TSFD – F(C) Act, 1980 – Diversion of 4.32 Ha of forest land for improvement of existing road and widening road from Narsapur-G to Gollamada Via Anjani Thanda, Thimmapur of Narsapur (G) Mandal in Kusli, Pyaramoor and Narsapur RFs of Nirmal Division in favour of District Panchayat Raj Engineer, Nirmal – Additional information sought - Report submitted – Reg.

TSFD – F(C) Act, 1980 – Diversion of 4.32 Ha of forest land for improvement of existing road and widening road from **Narsapur-G to Gollamada** Via Anjani Thanda, Thimmapur of Narsapur (G) Mandal in Kusli, Pyaramoor and Narsapur RFs of Nirmal Division in favour of District Panchayat Raj Engineer, Nirmal – Additional information submitted – Further report submitted – Reg.

Sub:- TSFD – F(C) Act, 1980 – PMGSY Ph.X - Diversion of **4.32 Ha** of forest land for Road from **Narsapur to Gollamada** Via Anjani Thanda, Thimmapur of Narsapur (G) Mandal in Kusli RF, Pyaramoor RF and Narsapur RFs of Nirmal Division in favour Panchayat Raj Engineer, Nirmal – Further Report submitted – Reg.

**Field Inspection Notes of Sri Siddharth Vikram Singh, I.F.S., Nirmal on 05.07.2021 in Nirmal Range, area proposed for diversion of 4.32 of Forest land

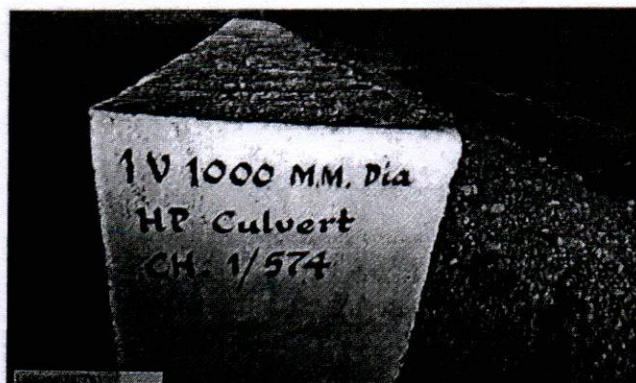
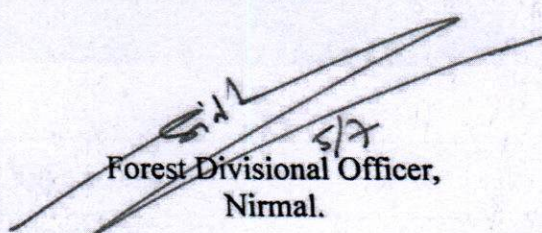
During inspection, it was noticed that User Agency has violated FCA,1980 norms and started road construction. Work in violation has been carried out by the User Agency which are following :

1. The User Agency has attempted and nearly completed the road work over an length of 5.760 Km in the proposed area and complete road has been black topped. Hence the forest area involved in violation comes to 5.760 Km X 7.50 Mtr width = 4.32 Ha. Even the condition of laying speed breakers at every 500metre length to control speed and signage on both sides regarding wildlife protection has not been followed.
2. Some culverts which are just outside the RF and bordering RF are yet to be plastered and cemented. Photos of some of the completed culvert is attached as above.

Show cause noticed has been issued to the user agency vide this office Rc. No. 2440/2020/S1, Dated 05.07.2021.
